Desert Sands Subdivision

City of El Paso — City Plan Commission — 7/12/2018

SUSU18-00036 — Major Preliminary - REVISED

ATTACHMENT 2 Cont.

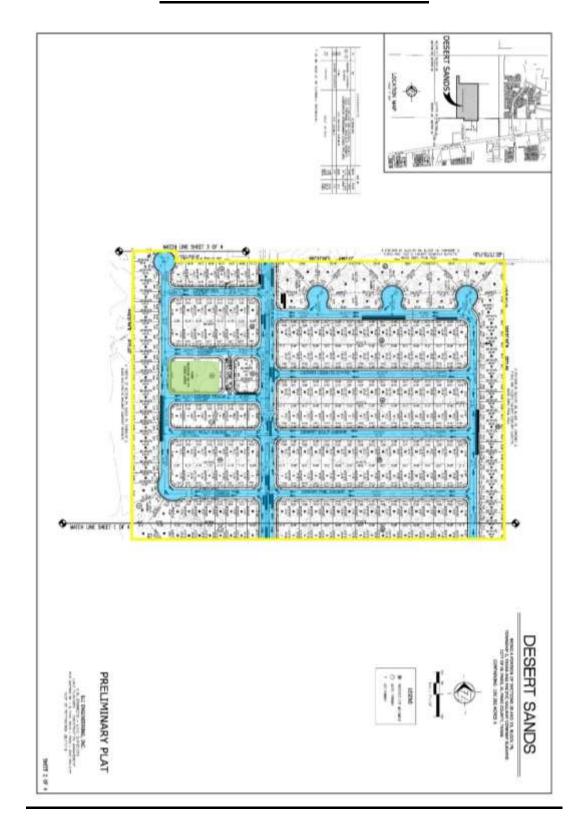
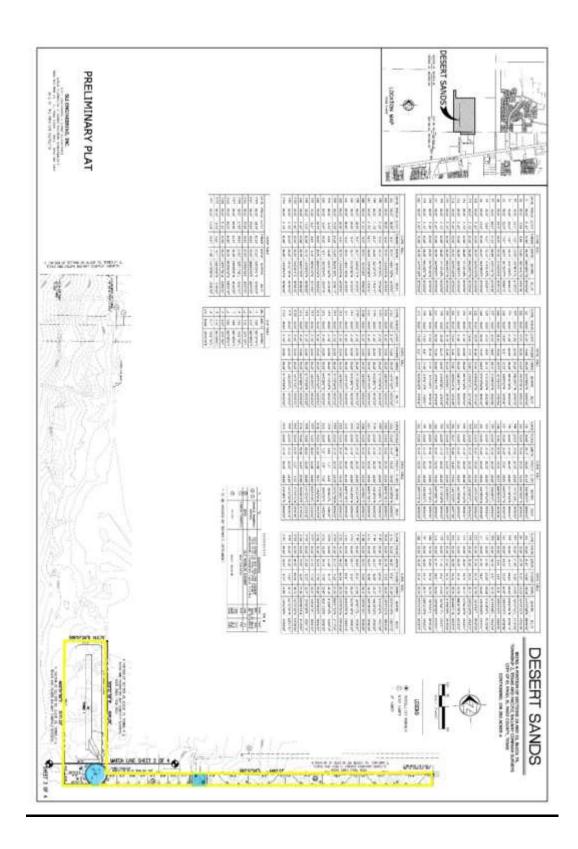
- 1. Illustrate storm-sewer line routing better in order to clarify where each watershed ultimately belongs respective to phasing.
- 2. Verify northernmost pond is of adequate capacity for upstream watershed runoff.
- 3. Update and verify FEMA flood zone FIRM panel information to include 480214-0037B.

Developer will need to coordinate with EPE Operation Departments (Transmission and Distribution) for the proposed improvements or disturbance within the dedicated easement area – Labeled as "Z" on plans.

- 1. EPWater does not object to this request as long as the future lift station lot is shown and label on plat.
- 2. All existing PSB easement shall be shown on plat.
- 3. During the improvement work of the site, the Owner/Developer shall safeguard the existing 16-inch diameter water main and appurtenant structures located within the easement. If any water main facilities are damaged during the improvement work, the Owner/Developer is responsible for the repair costs.
